Subject: WPPSS NUCLEAR PROJECT NO. 2
RESPONSES TO ROUND ONE QUESTIONS
SET NINE, REACTOR SYSTEMS BRANCH (RSB)

WPPSS NUCLEAR PROJECT NO. 2
RESPONSES TO ROUND ONE QUESTIONS
SET NINE, REACTOR SYSTEMS BRANCH (RSB)

RESPONSES TO
REACTOR SYSTEMS BRANCH (RSB)
QUESTIONS 211.049 - 211.106

FIGURE 211.51-1

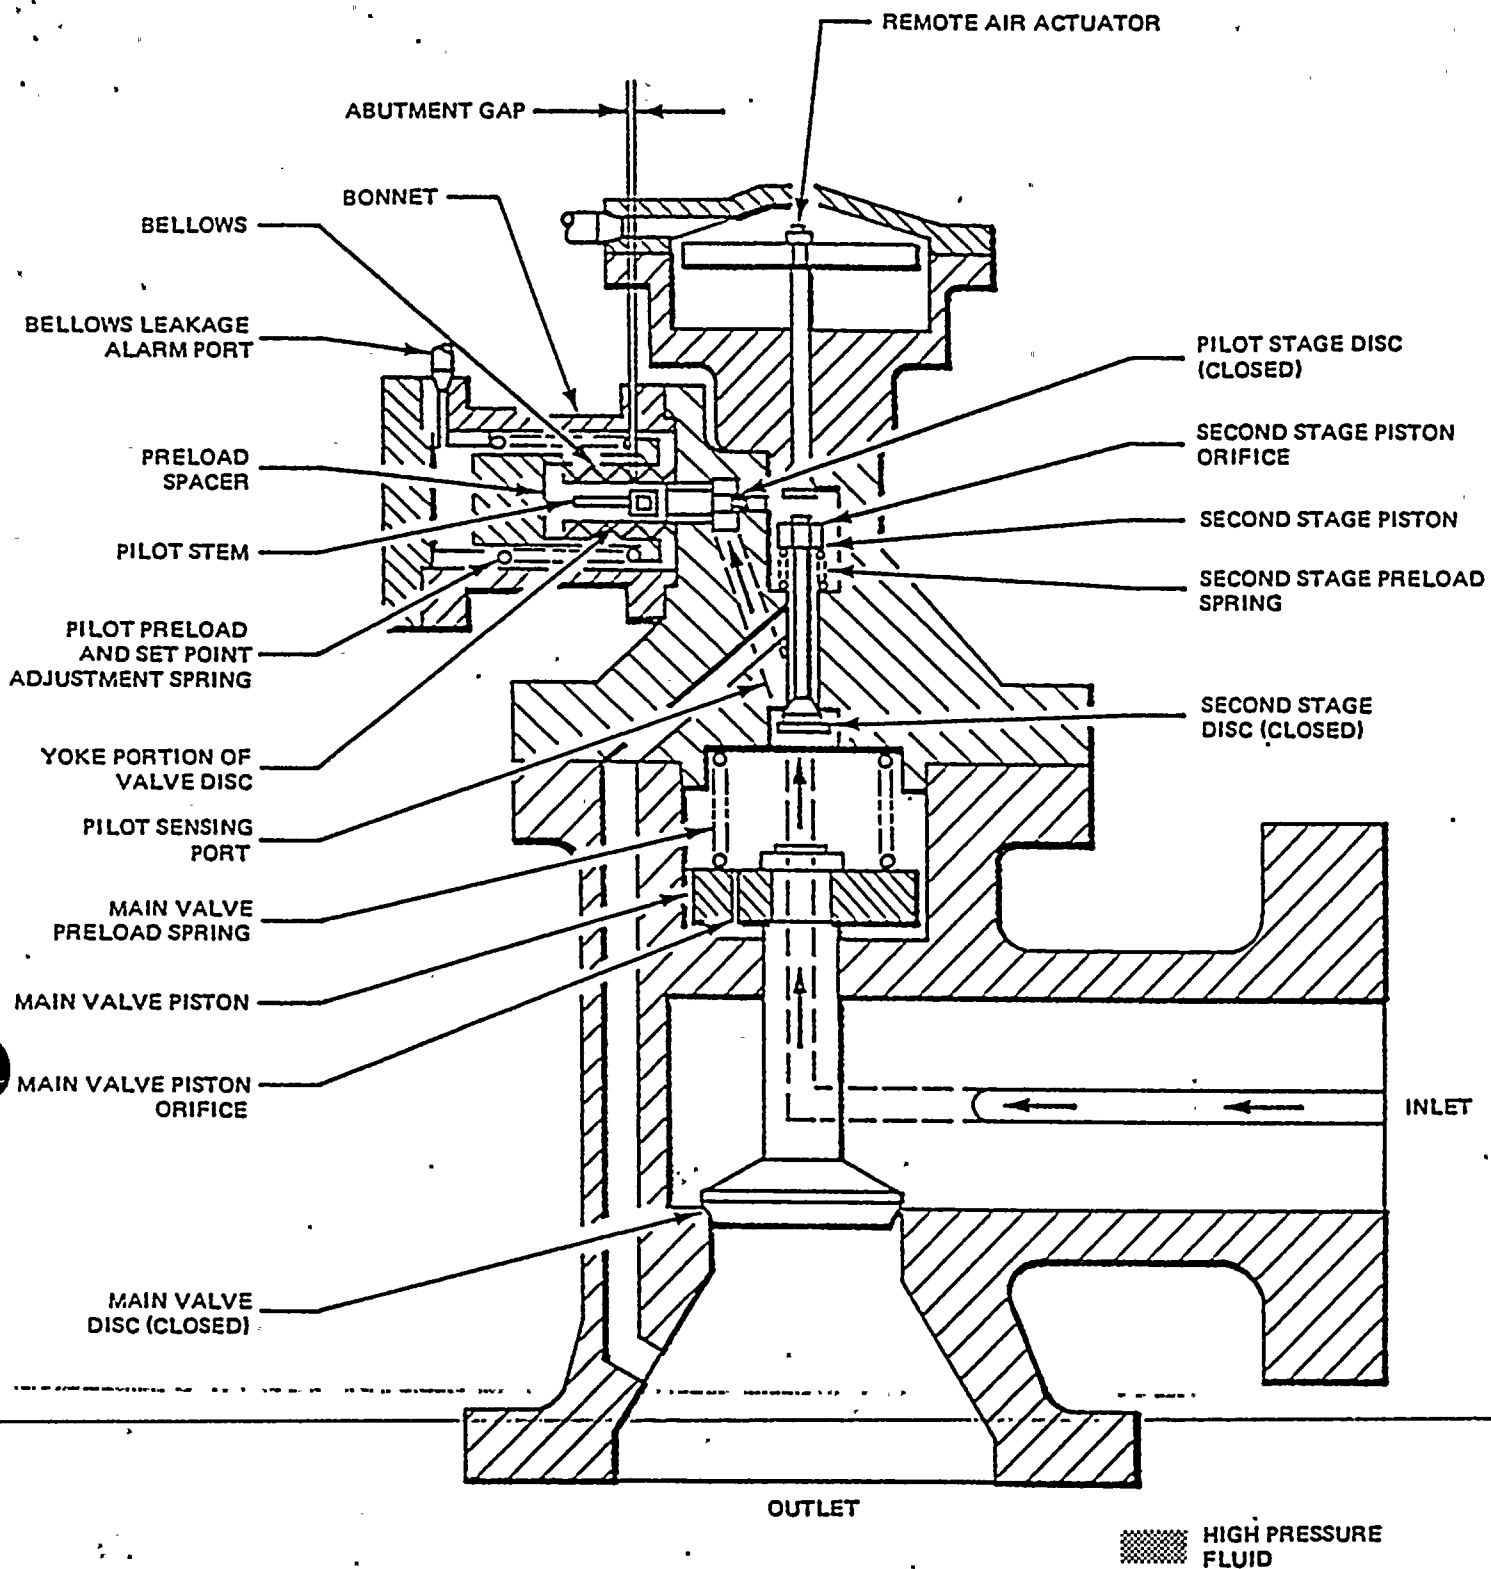
The performance of essentially all types of safety/relief valves has been below the expectations for this type of safety-related component. Based on the number of reportable events involving malfunctions of these valves in operating boiling water reactors (BWRs), we believe that significantly improved performance of the safety/relief valves (SRVs) should be required of the SRVs installed in new plants such as the WNP-2 facility. Accordingly, provide a detailed description of the provisions you will incorporate in the SRVs of the WNP-2 facility which represent an improvement over the SRVs of presently operating BWR plants in the six areas listed below. In responding to this item, explain why or how your additional provisions will provide the improvements which we seek in the performance of the SRVs. Finally, identify the SRV manufacturer.

- a. Valve and Valve Operator Type and/or Design. Provide a discussion of your proposed improvements in the air actuator, especially in the materials used for such components as the diaphragms and the seals. Discuss the safety margins and confidence levels associated with the air accumulator design. Discuss the capability of the reactor operator to detect low pressure in both air accumulators.

Past BWRs utilized reversed-seated, pilot-operated, safety/relief-type valves as shown in Figures 211.051-1 and 211.051-2. WNP-2, which is a GE BWR/5, utilizes a conventional-type simple, direct-acting, spring-loaded, safety/relief valve with an auxiliary pneumatic actuator assembly with solenoid valves to provide for an independent mode of operation for relief service based upon user/operator command. (See Figures 211.051-3 and 211.051-4.) As such, the safety/relief

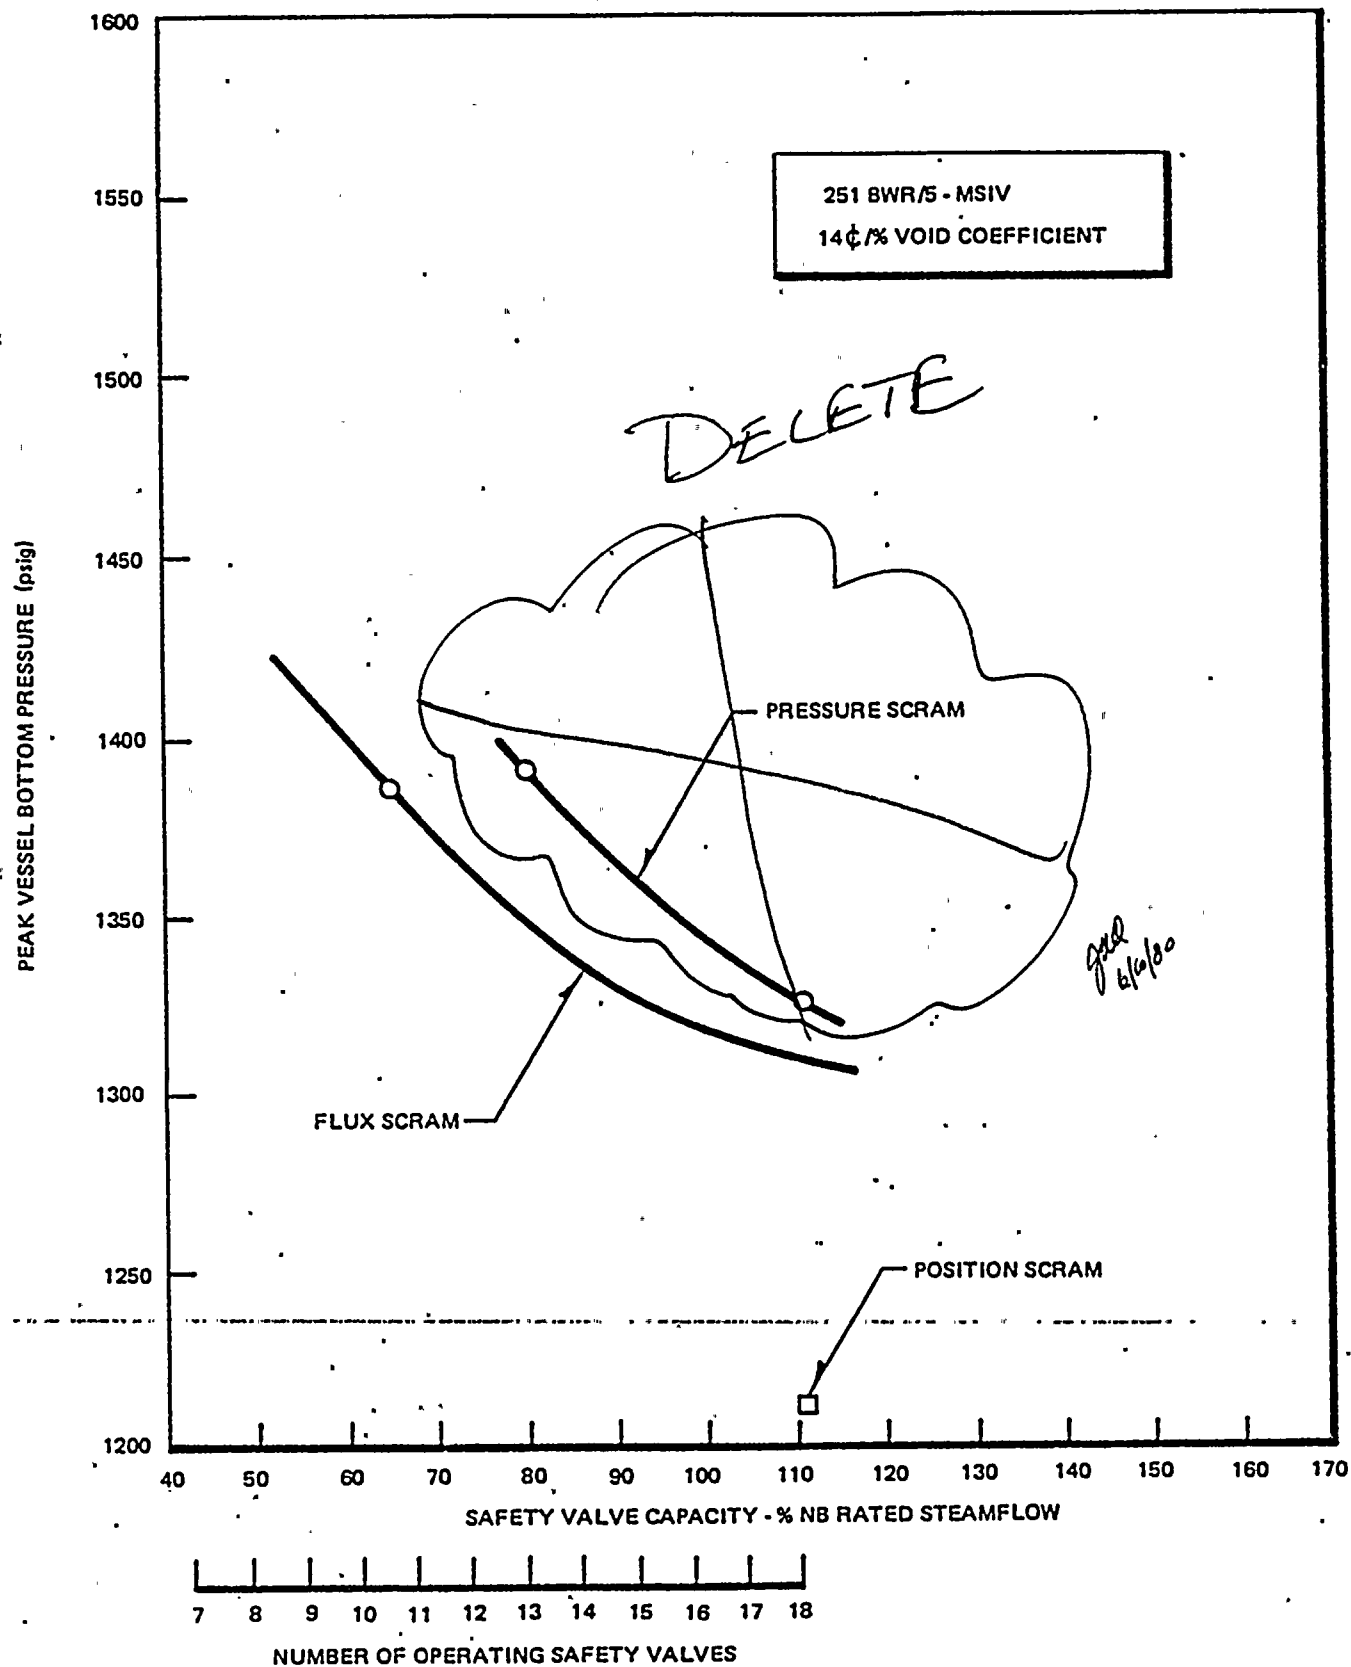
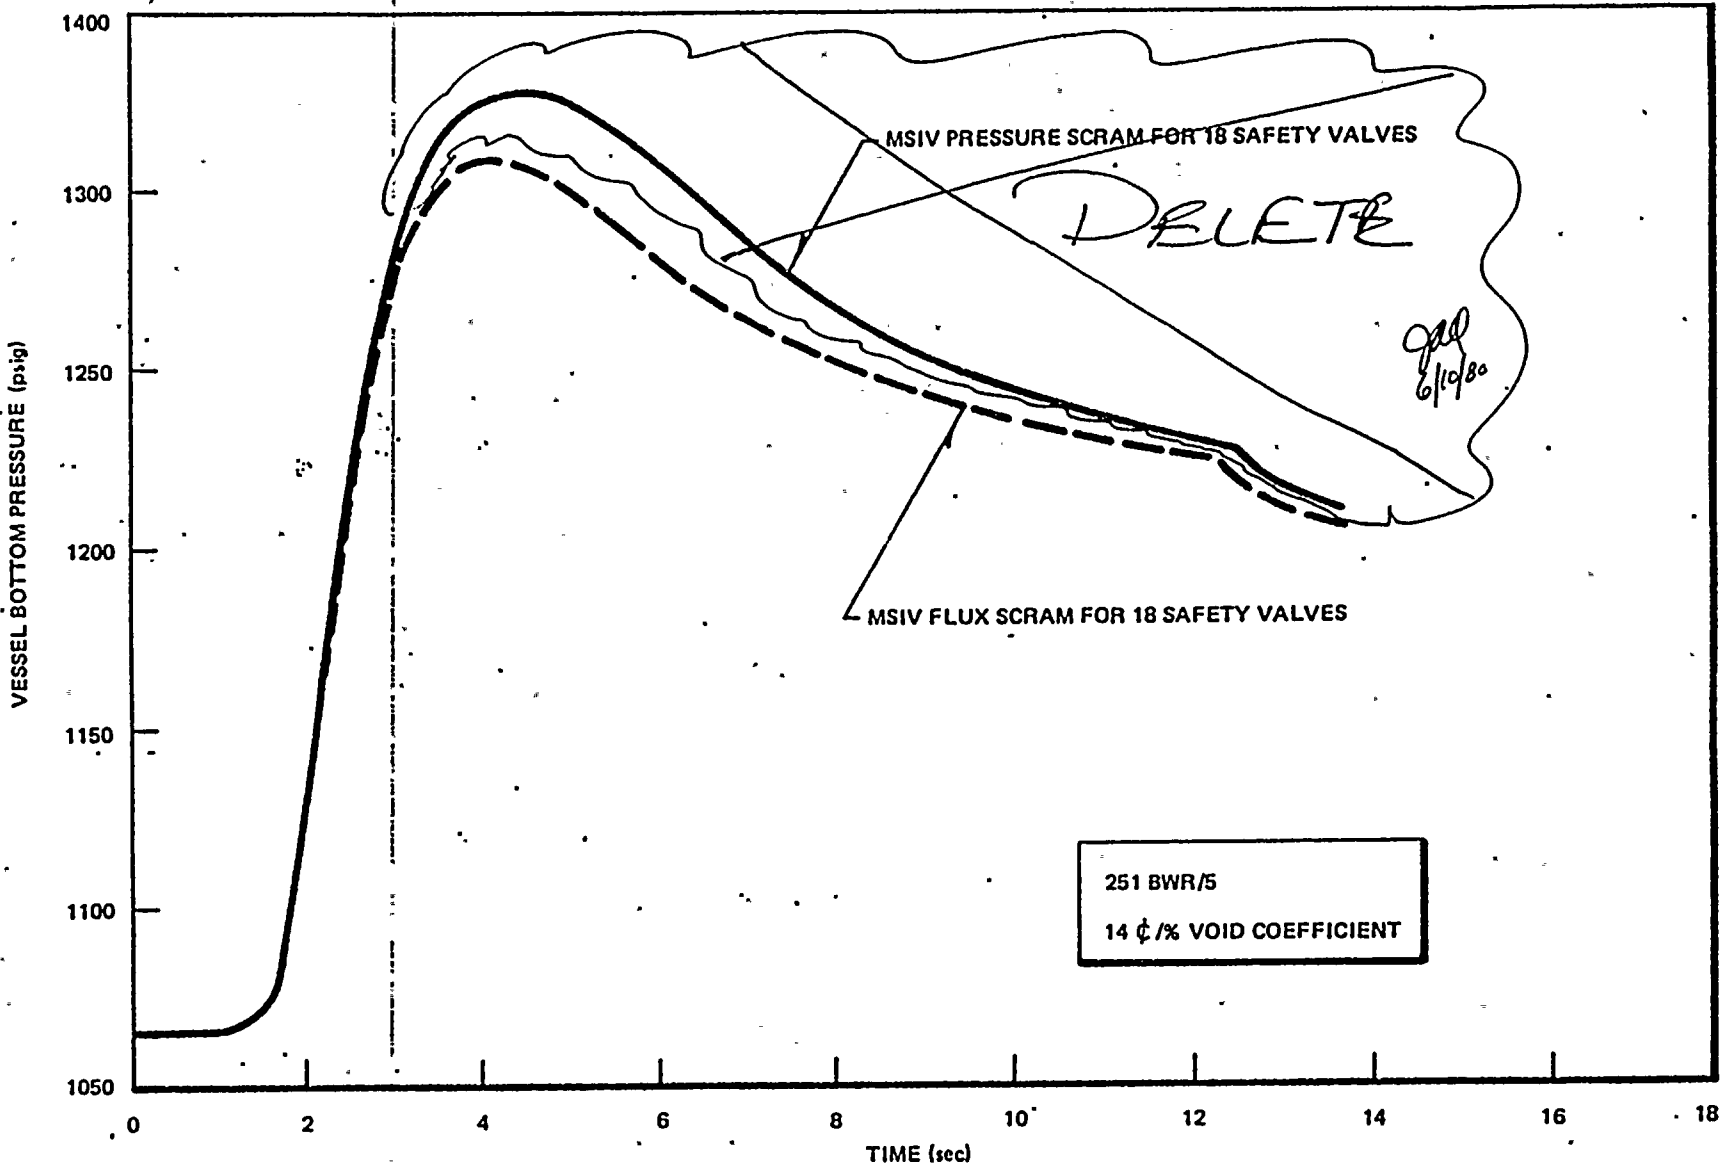
The peak pressures occurring after closure of the MSIV's due to scrams initiated by high flux and high pressure signals are not consistent between Figures 5.2-4 and 5.2-5 of the FSAR. Further, Section 5.2.2.2.3.1 erroneously states that generator load rejection with bypass failure is shown on Figure 5.2-4. Correct these inconsistencies.

The inconsistencies stated are corrected in revised 5.2.2.2.3.1 and revised Figures 5.2-4 and 5.2-5. The curve for peak vessel bottom pressure from pressure scram in Figures 5.2-4 and 5.2-5 were mistakenly placed onto these figures and have been deleted. The reference to generator load rejection with bypass failure in 5.2.2.2.3.1 was incorrect and has been deleted.*

The parametric relationship between peak vessel (bottom) pressure and safety/relief valve capacity for the MSIV transient with high flux scram is described in Figure 5.2-4.

Also shown in Figure 5.2-4 is the ~~parametric relationship between peak vessel (bottom) pressure and safety/relief valve capacity for the generator load rejection with a coincident closure of the turbine bypass valves and direct~~ ^{FOR POSITION SCRAM WITH 18 VALVES CAPACITY.} ~~scram, which is the most severe transient when direct scram is considered.~~ Pressures shown for flux scram will result only with multiple failure in the redundant direct scram system.
